U.S. DEPARTMENT OF ENERGY (DOE) RESPONSES TO U.S. NUCLEAR REGULATORY COMMISSION (NRC) COMMENTS ON DOE'S THERMOHYDROLOGY TESTING AND MODELING PROGRAM

Reference: Ltr, Bell to Brocoum, dtd 1/23/97

ENCLOSURE 1

Figure 1

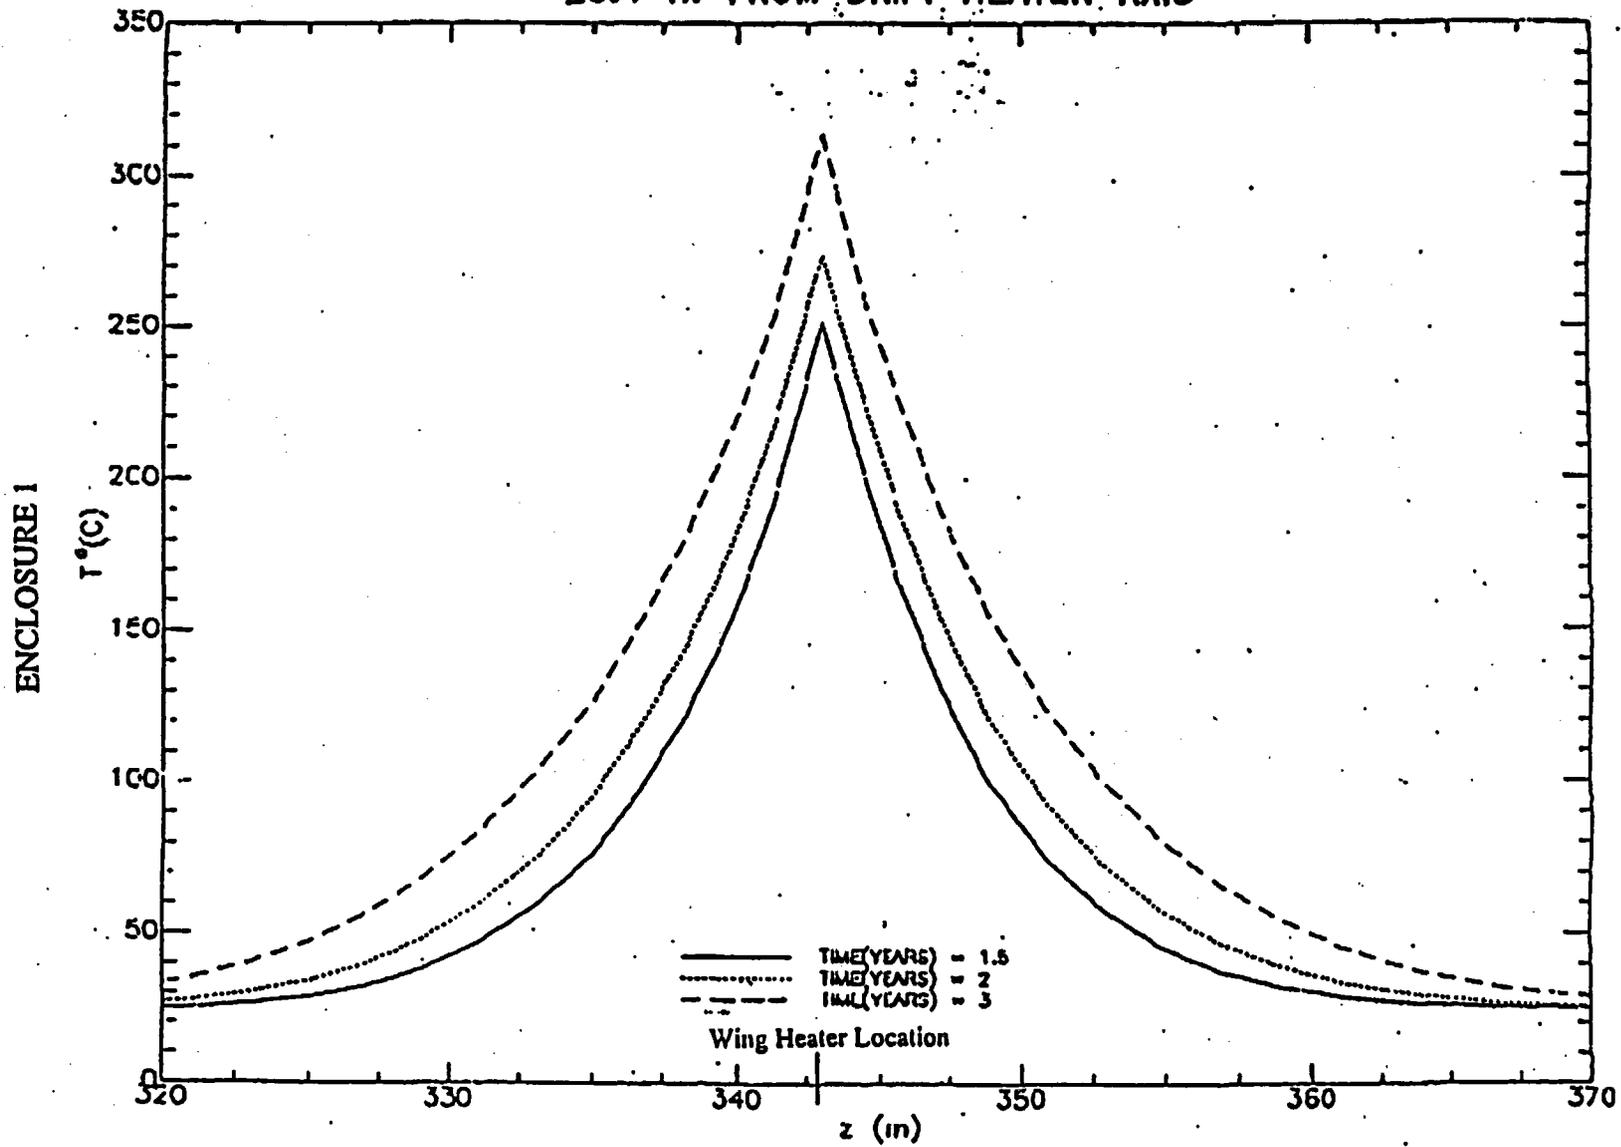
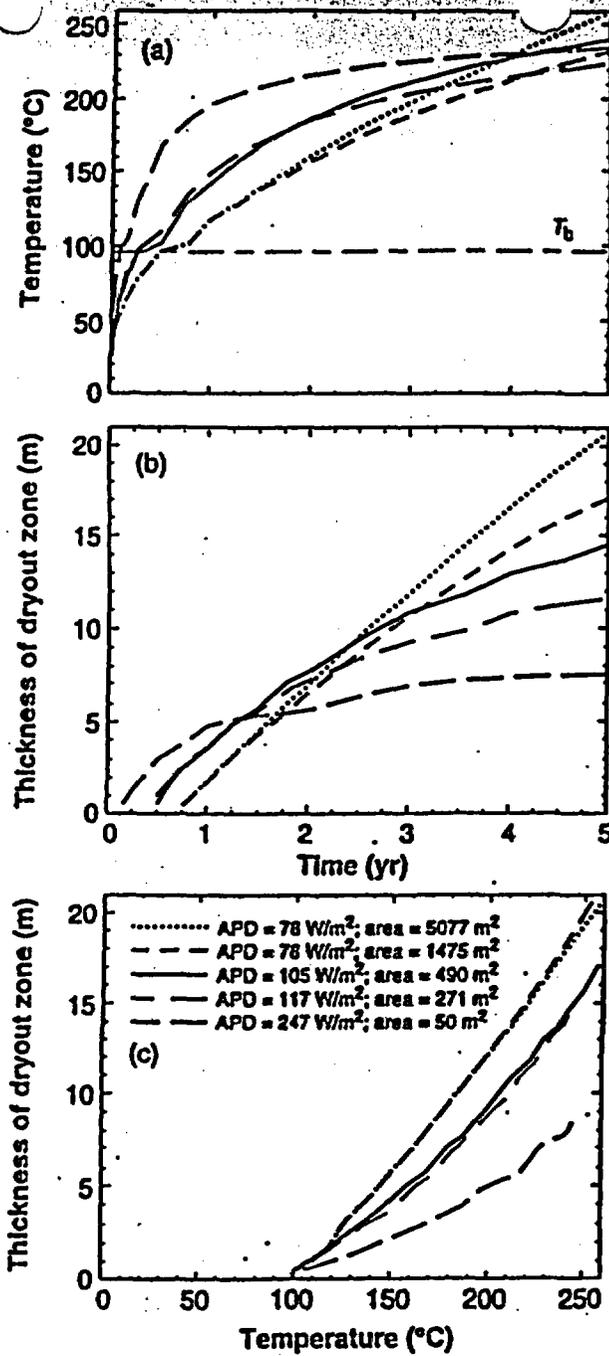
Comment 1: *A field-scale heater test at thermal loads much higher than those expected at the repository poses a risk of masking the phenomenon of gravity-driven liquid water flow toward the heaters, which might occur at the lower temperatures expected for the repository.*

“A field-scale heater test at thermal loads much higher than those expected at the repository poses a risk of masking the phenomenon of gravity-driven liquid water flow toward the heaters, which might occur at the lower temperatures expected for the repository.”

Peak temperatures are predicted to occur only locally around the wing heaters (possibly as high as 350°C to 400°C based on a worst case (hottest), conduction-only, zero flux model) and are largely a function of the low thermal conductivity of the matrix of the repository rock (Topopah Spring Tuff). This same low thermal conductivity means that the effect is localized, as shown in Figure 1 (enclosed).

- The peak predicted rock temperature of 382°C occurs at the outer half of the wing-heater array, which is well away (about 7 meters) from the heated drift wall. Note that 382°C was determined with the use of a conduction-only model and a value of thermal conductivity ($K_{th} = 1.67\text{W/m}^\circ\text{C}$) that is probably low for the DST area. With the use of a thermal-hydrological model and a percolation flux of 0.05 mm/yr, a peak rock temperature of 312°C is predicted for the hottest portion of the wing-heater array. If a percolation flux of 5 mm/yr is assumed, the peak temperature is only 222°C. Therefore, the higher temperatures at the wing heaters reported earlier are worst case scenarios. The relatively high temperatures around the wing heaters (as compared to the vicinity of the heated drift) are the result of: (1) attempting to drive condensate from the outer boiling region towards the heater drift and (2) the small diameter of the wing-heater boreholes. The relatively high temperatures are only applicable to the rock in the immediate vicinity of the outer wing heaters, which is well removed from the heated drift.
